1st DRB SUBMITTAL
 pre-app no.: 1006-PA-2018
 VALLEY LIGHT GALLERY
 7120 e. mercer lane
 scottsdale, arizona 85254
 date issued: august 21, 2019
 project # 18044

SITE PLAN

a-1.1

01. SITE PLAN

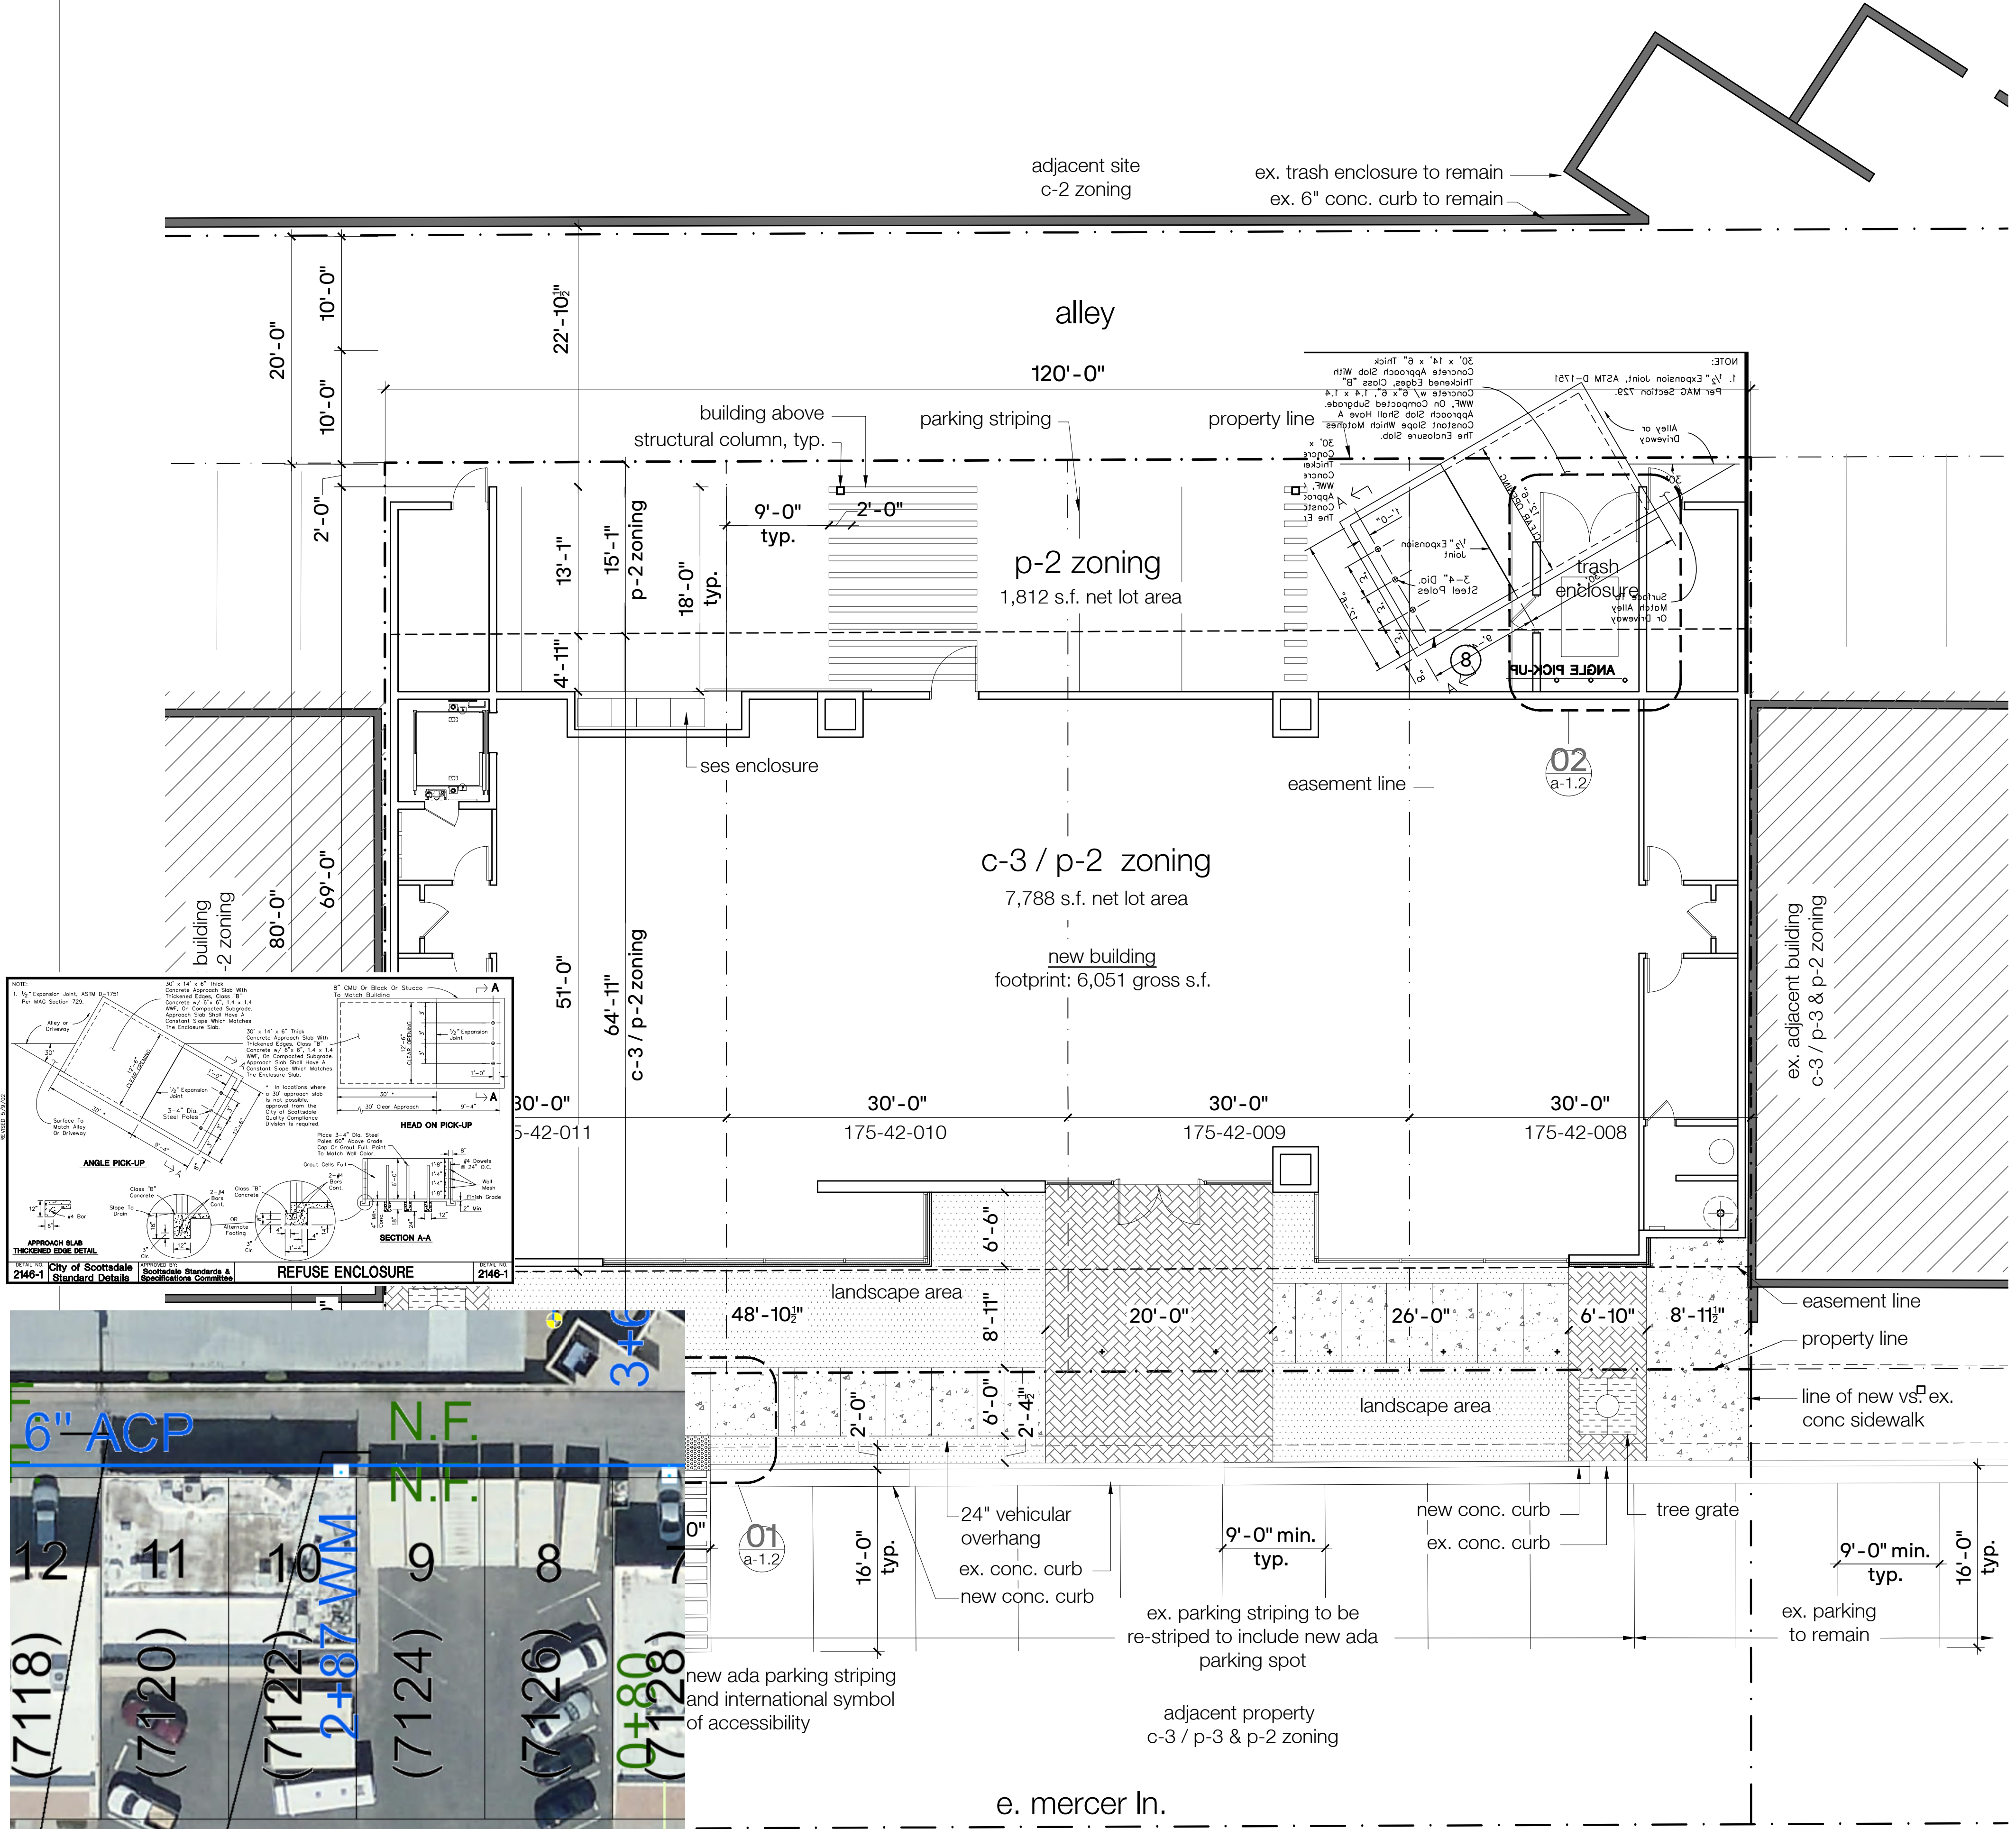
Show the water and sewer mains serving the site. Water meter will require a backflow preventor. Sewer service for commercial use must be 6-inch diameter. Show and callout on the site plan.

Refuse enclosure must be per the COS Standard Detail 2146-1 at a 30 degree to the drive aisle and angled for collection from the east. (for a truck driving east)
